Service Bulletin

Brake Disc interference with transaxle Hardware

Bulletin No: JC-020-12

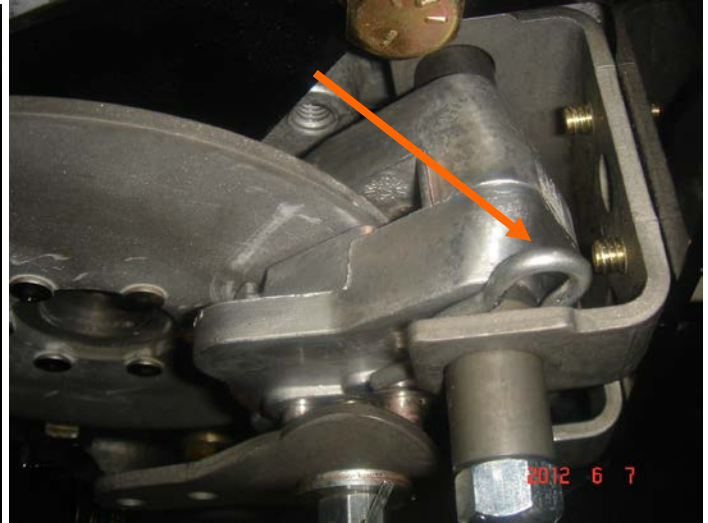
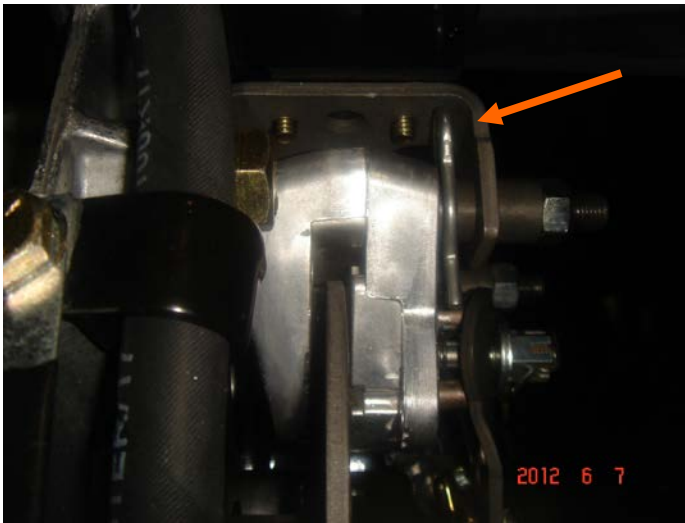
Issue: The new floating brake caliber and brake disc should help reduce brake wear on the Steiner 440. We have discovered that on some tractors the brake disc can float sideways far enough allowing the brake disc to rub the nut of the bolt that holds the transaxle support.

Cause: Too much side travel in the brake caliber and disc.

Action required: Install a locking pin (548602) to restrict the side travel of brake caliber.

1. To get access to the brake assembly, flip the seat forward and unsnap the rear transaxle fill hose and push it away.
2. Install the locking pin by snapping it over the outside caliber slide, between the mounting bracket and the brake - (see pictures). The pin will hold the brake assembly from sliding sideways and allowing the disc to contact the nut.
3. Snap the fill hose back into the holder and flip the seat back down to complete the repair.
